General Inspection (Snapshot) Report Six

Waterproofing systems for wet areas

September 2021

Figure 2 Example of a missing drainage flange

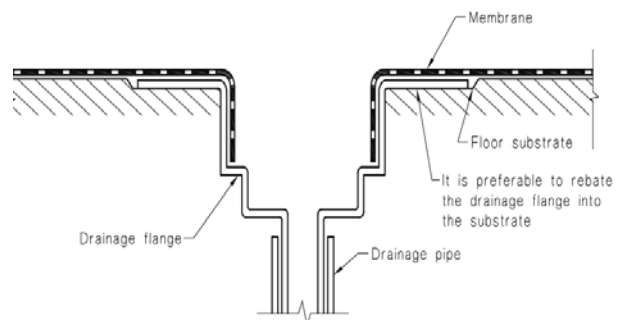
Building and Energy inspected seven wet areas where the drainage flanges in showers did not comply with the specifications in AS 3740-2010

Figure 2 below shows an example of a shower floor where a drainage flange was not installed.

Figure 4 Example of a waterproof membrane in a shower that did not have the required thickness

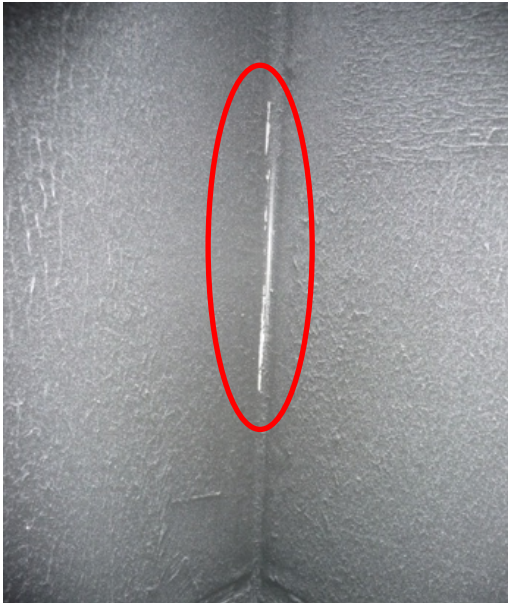
Building and Energy cut samples from several dried waterproof membranes. In all nine wet areas inspected for appropriate dry film thickness, the measured sample did not have the dry film thicknesses recommended by the manufacturers. In one case, the dry film thickness was only 0.25 mm.

Figure 4 below shows an example where the thickness of waterproof membrane in the corner of a shower was inadequate.

Inadequate waterproof membrane thickness is a problem because thin membranes are more easily damaged. They are also less elastic and do not accommodate building movement as well as membranes that are the recommended thickness. Manufacturers' warranties may also be invalid if the membrane is not applied according to the manufacturers' recommendations. In one case, no waterproof membrane was installed in a shower.
